**Permit #:** 20285  
**Permit Date:** 09/25/2020  
**Permit Type:** Design Study  
**Permit Identifier:** DS 20-285 (Saparov)  
**Track:** Two  
**Withdrawn:** 09/21/2021

**Project Description:** Remodel and restore existing 757 SF Single story residence/construct a 674 sf Single story addition in the rear yar/consturct a new 439 SF roof deck and storage access via a spiral staircase

**SAPAROV RESIDENCE**    **A1.1**  
3 SE OF 4<sup>TH</sup> ON SAN ANTONIO  
APN: 010-253-016

SAPAROV RESIDENCE A1.1  
3 SE OF 4<sup>TH</sup> ON SAN ANTONIO  
APN: 010-253-016

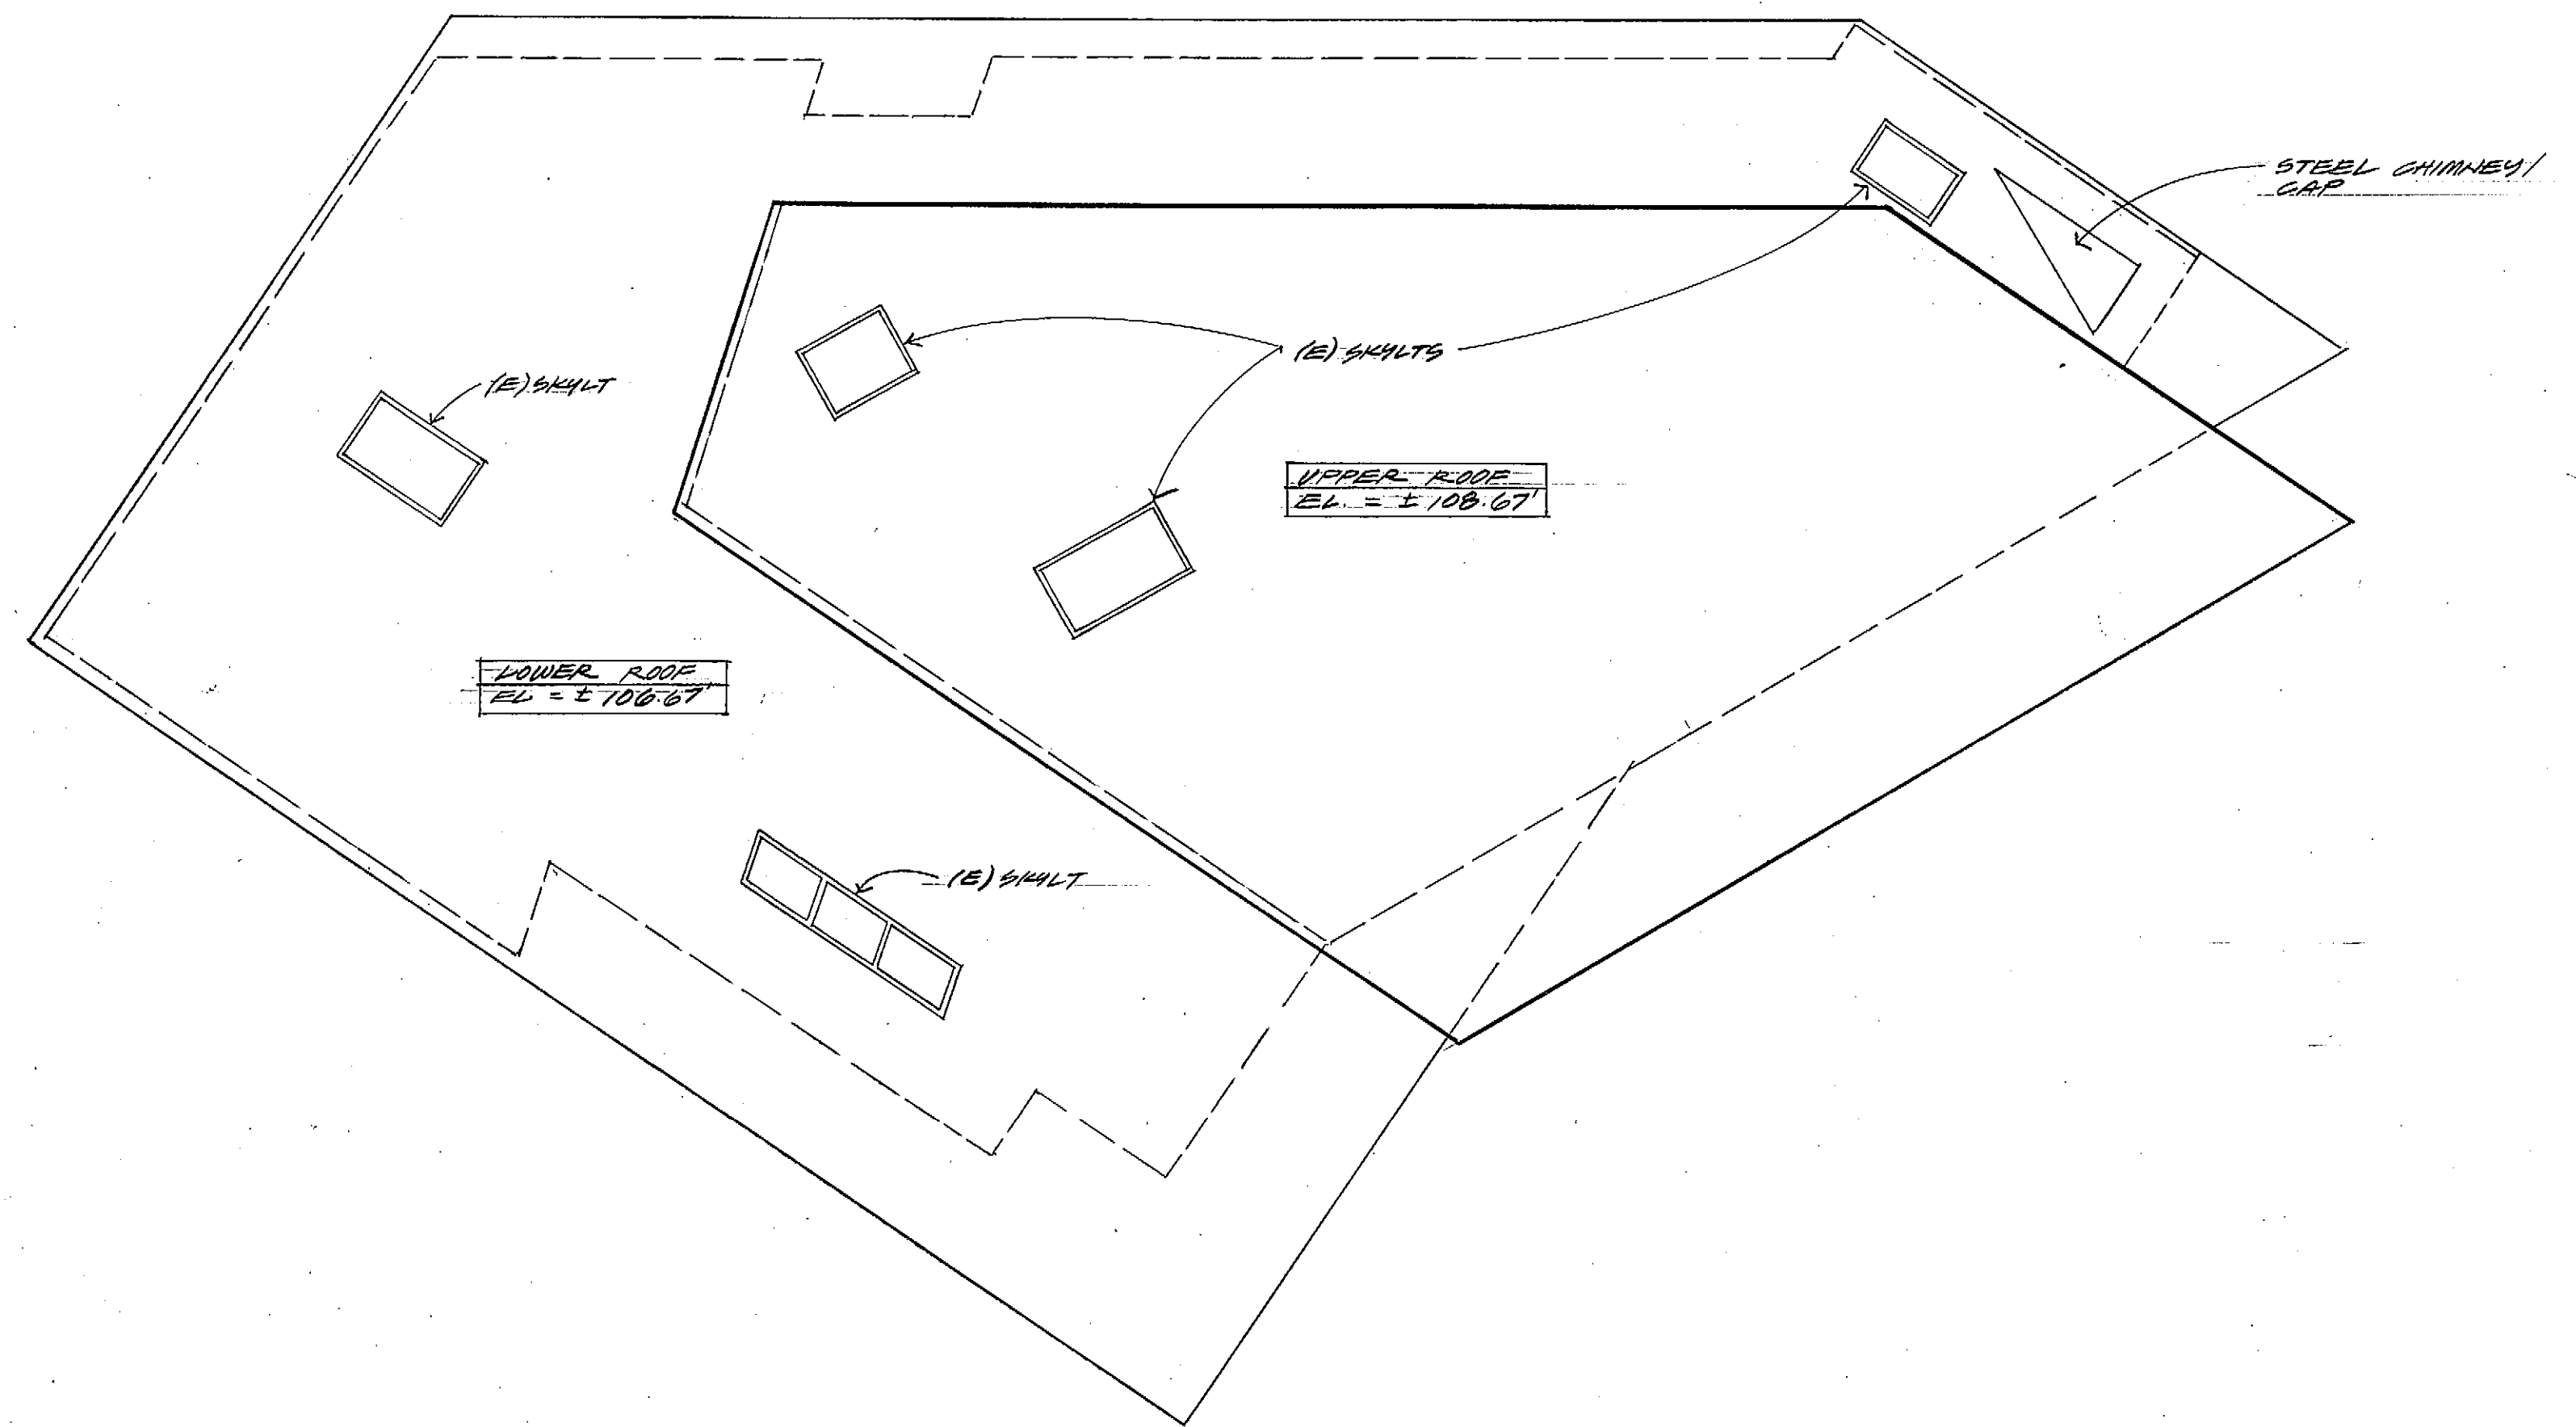
The proposed concrete walking pads (see Sheet A1.1) appear to be compatible with the original intent of the garden however a landscape plan should be submitted to the Historic Resources Board for review so they may ascertain if the project plans are consistent with the Cultural Landscape Guidelines.

The proposed work is consistent with Standard One as long as a satisfactory landscape plan is developed that preserves remaining distinctive spatial relationships between the Chapman House and garden.<sup>3</sup>

SAPAROV RESIDENCE A5.0  
3 SE OF 4<sup>TH</sup> ON SAN ANTONIO  
APN: 010-253-0016

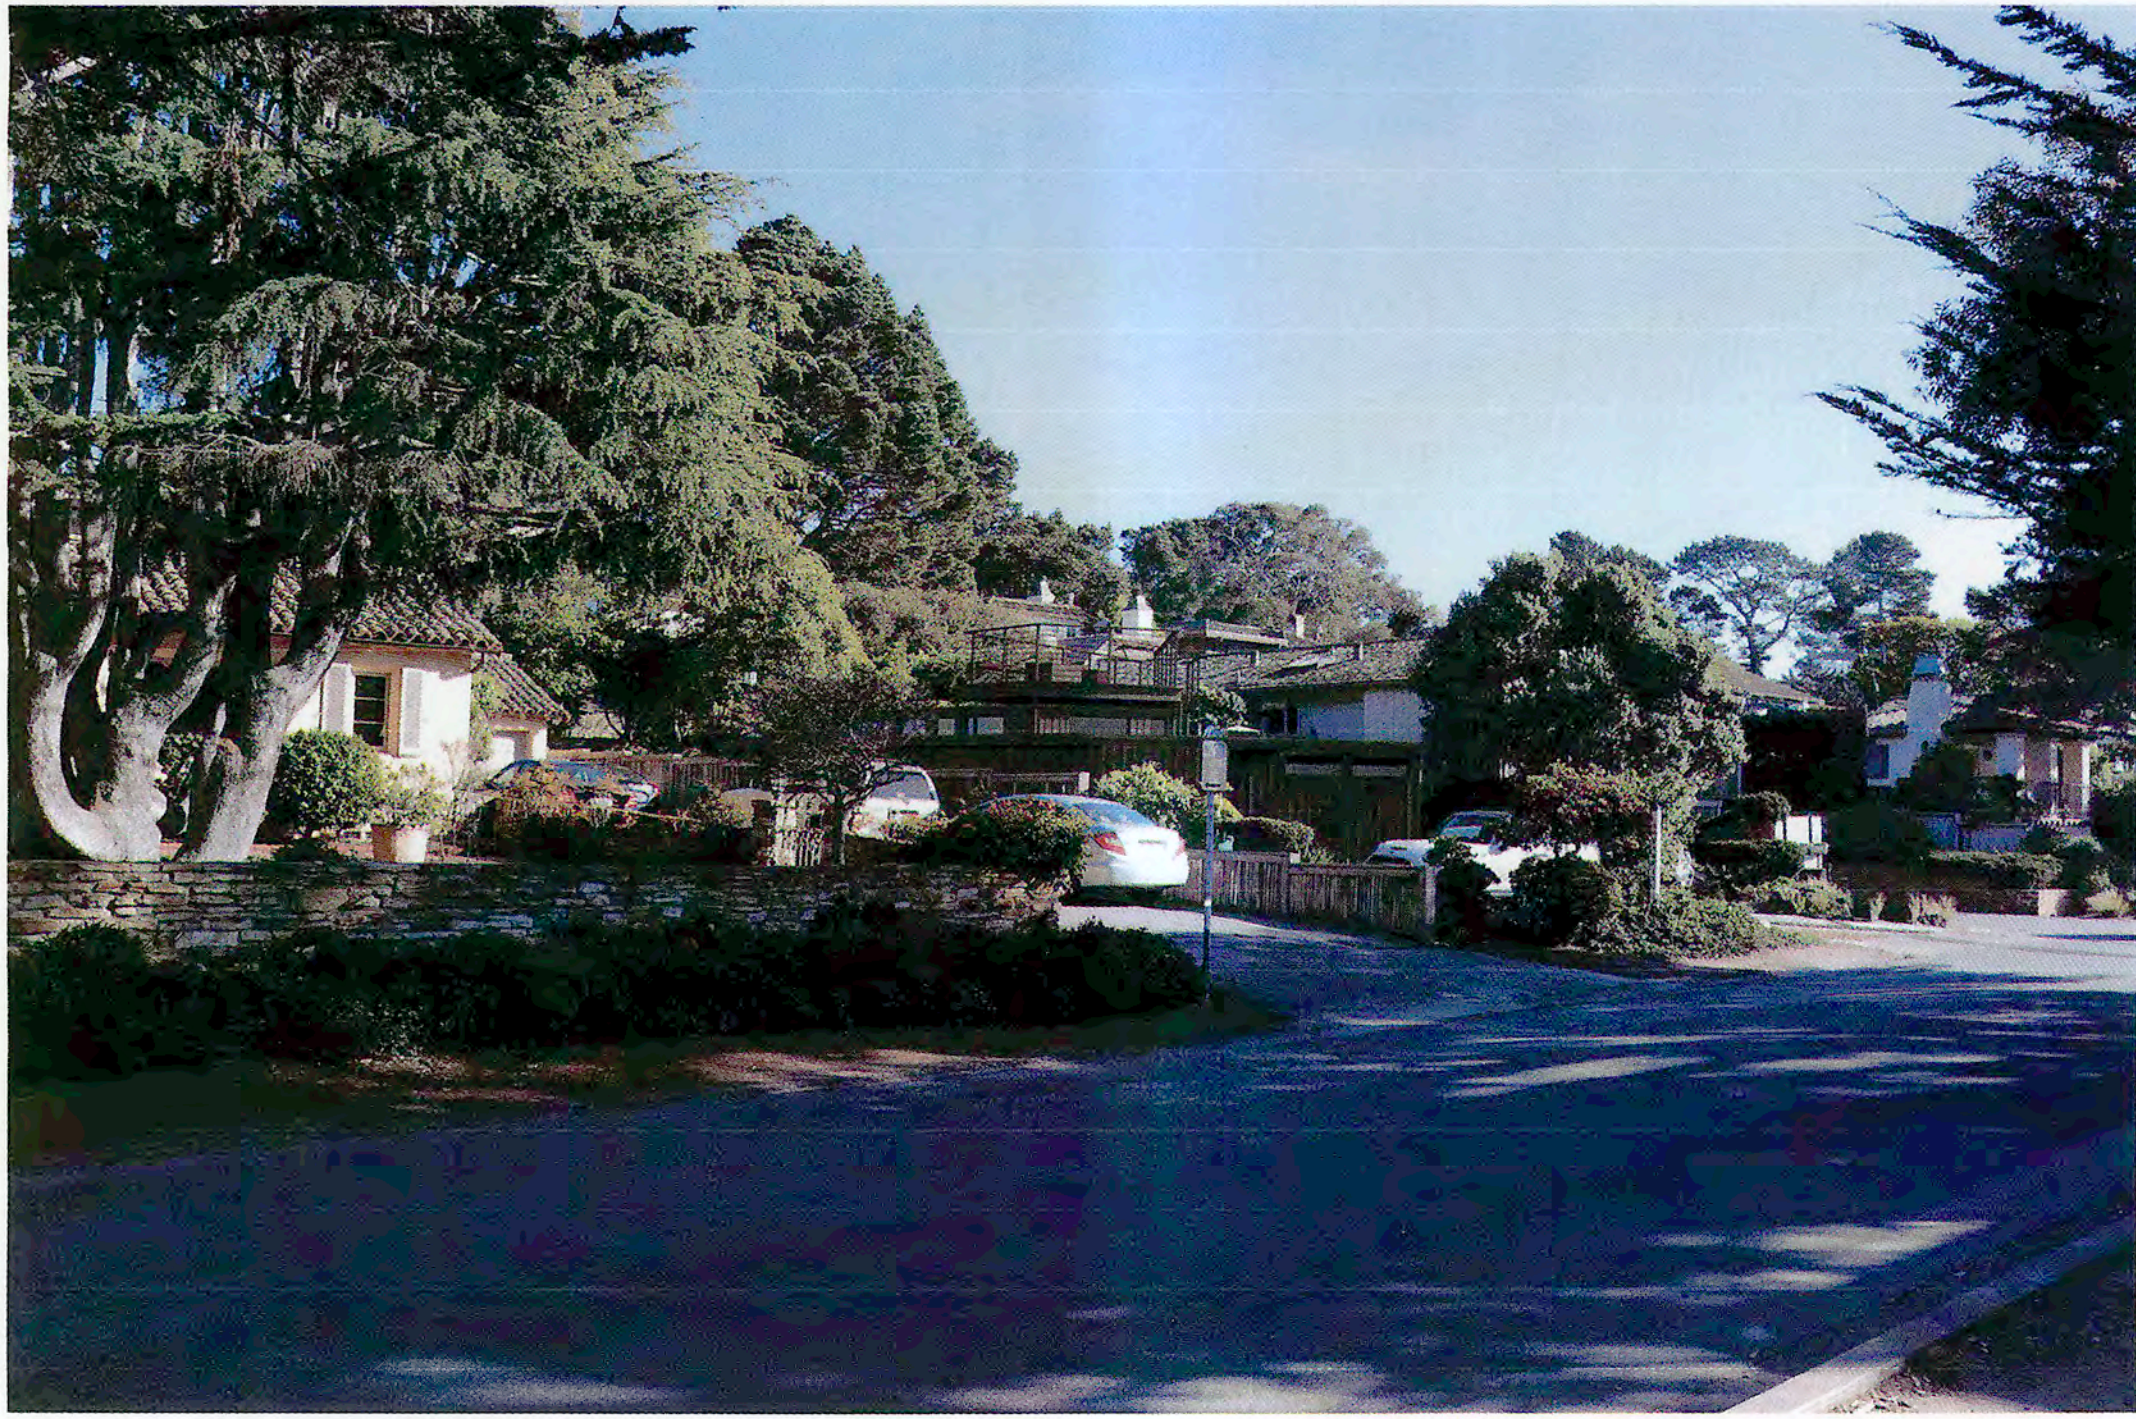
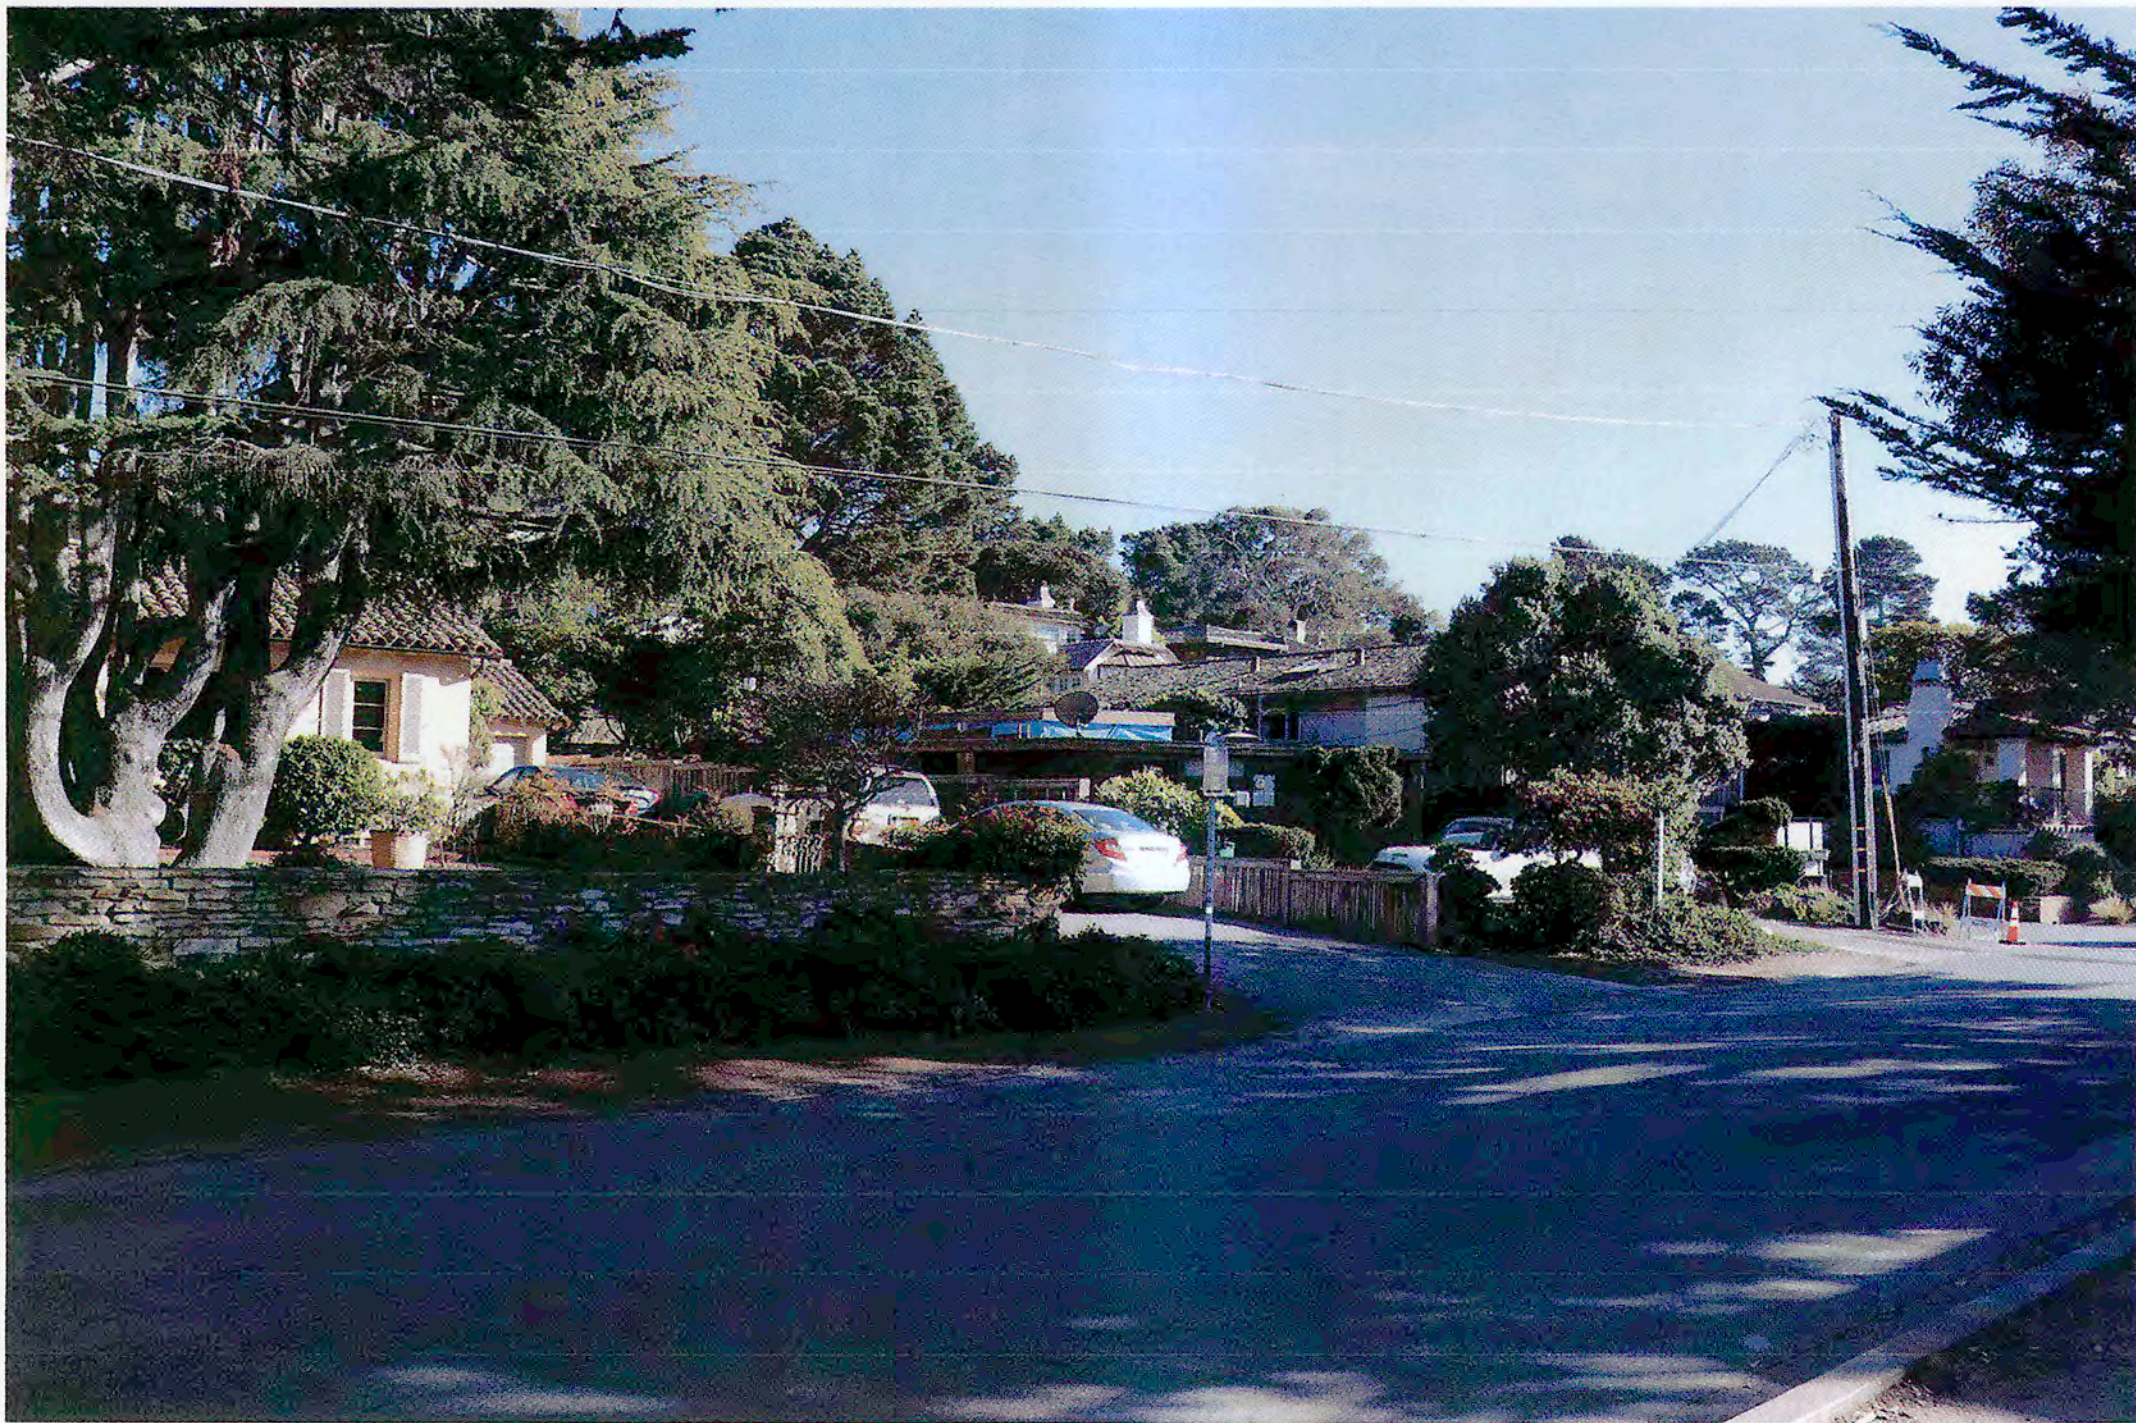
The proposed construction of a 439 square foot roof deck which will be accessed by a spiral staircase is clearly visible from the street and dominates the original design of the house (see Plans Sheet A6.0). The *Secretary of the Interior's Rehabilitation Guidelines* for roofs state that a new rooftop deck should be inconspicuous and minimally visible on the site and from the public-right-of-way and that the new deck should not damage or obscure character-defining features. In addition, Preservation Brief 14<sup>3</sup> states that in general:

The proposed construction of a 439 square foot roof deck which will be accessed by a spiral staircase is clearly visible from the street and dominates the original design of the house (see Plans Sheet A6.0). The *Secretary of the Interior's Rehabilitation Guidelines* for roofs state that a new rooftop deck should be inconspicuous and minimally visible on the site and from the public-right-of-way and that the new deck should not damage or obscure character-defining features. In addition, Preservation Brief 14<sup>3</sup> states that in general:
